Product Change Notification

1. ECN #: 296060

- TSM - .025 SQ. TERMINAL STRIPS

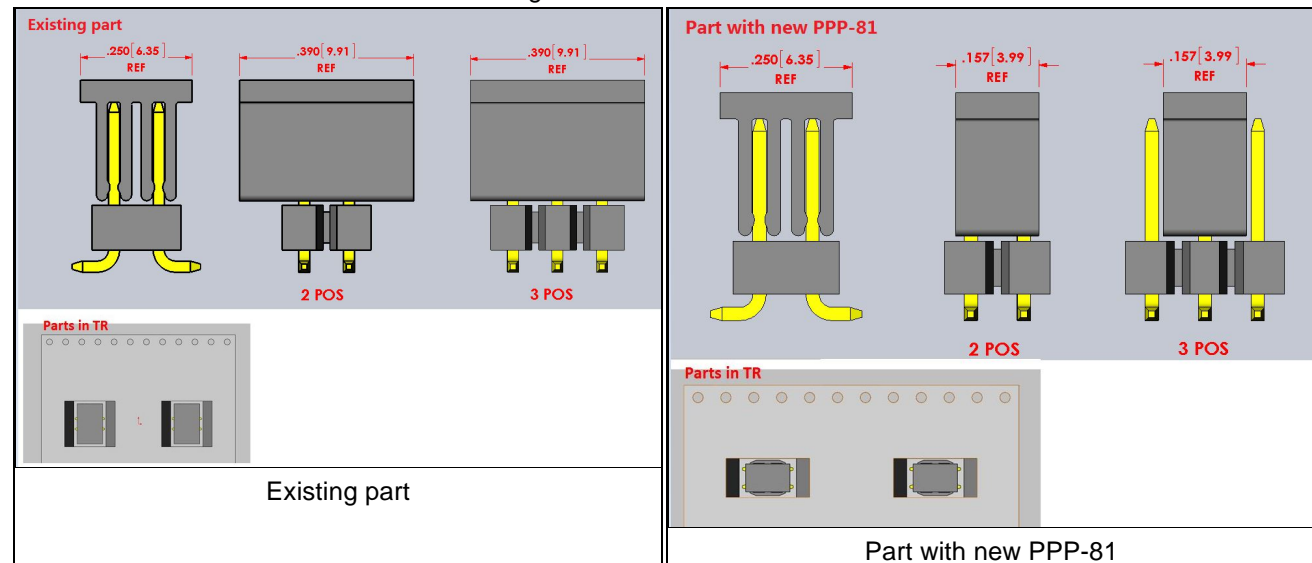
Change small position connector pick and place pad (-02 and -03 position connectors) from PPP-81 to PPP-06.

The new PPP-81 is narrower than the existing PPP-06.

Change is being made to improve pick and place pad placement and final assembly placement flexibility (closer together, if more than one is used). The change is being made for -P option for -02 and -03 positions and all packaging styles including -TR.

- Form - Pick and place pad option--- 02 and 03 positions will use new pick and place pad, this is a rolling change and there is some opportunity for mixed inventory on a limited basis.
